Part No.	Cable Length
DB25MF	1.83M

Item Number	DB25MF	Drawer	
Description	DB25 Male to DB25 Female Molded	Checked	
		Approved	
Material		Scale	
	A	Unit	MM
Drawing No:			
Remake	ROHS Compliant

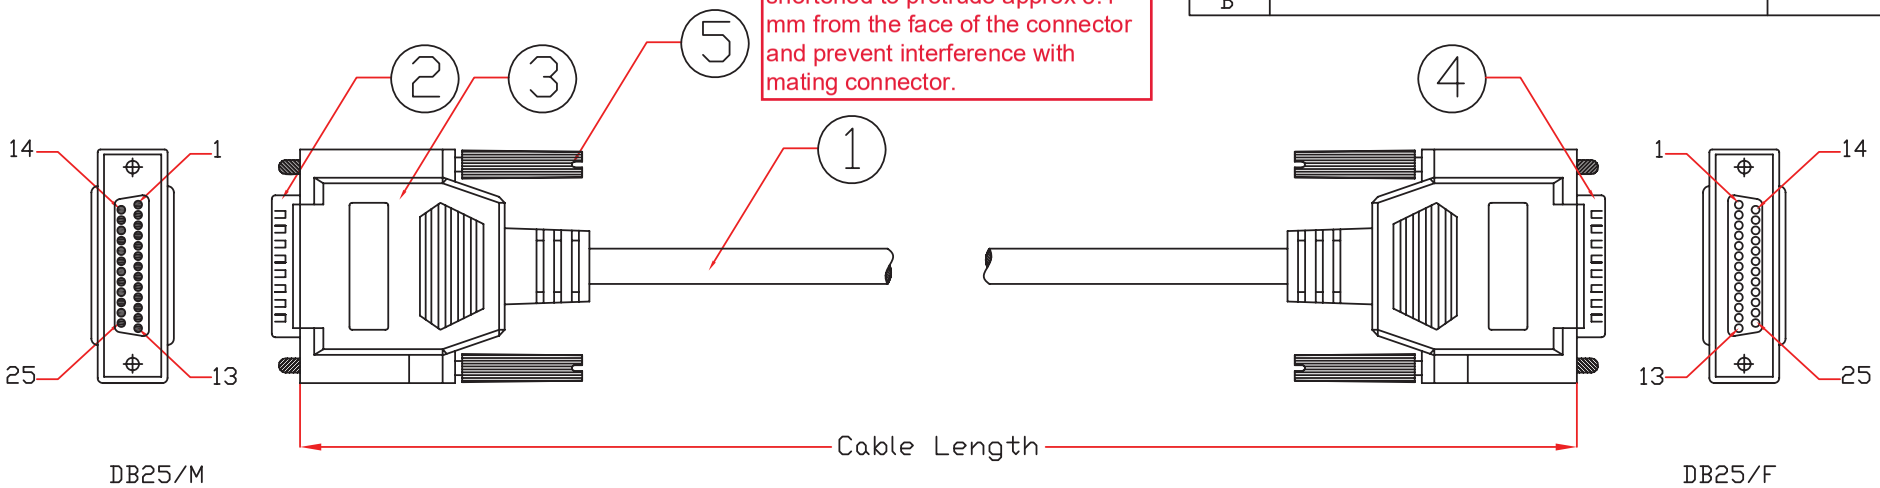
Note: Thumbscrews are being shortened to protrude approx 3.4 mm from the face of the connector and prevent interference with mating connector.
